**FINAL DRAINAGE REPORT
FOR
MOUNTAIN VIEW ACADEMY
TRACT H, CLAREMONT RANCH, FILING NO. 4
EL PASO COUNTY, COLORADO**

February 7, 2020

Add "PCD File No.
PPR-20-008"

Basin ID: _____

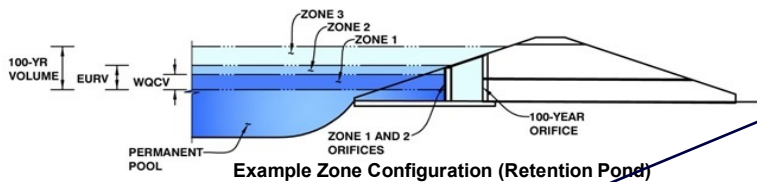
Adjust area & %imp to the sub-basins tributary to the pond (R1 and P1)

Change to user input. See Colorado Springs DCM Chapter 6 Table 6-2 for rainfall depths.

Will be reviewed on the resubmittal. Full Spectrum Detention is required. See comment on pg 9
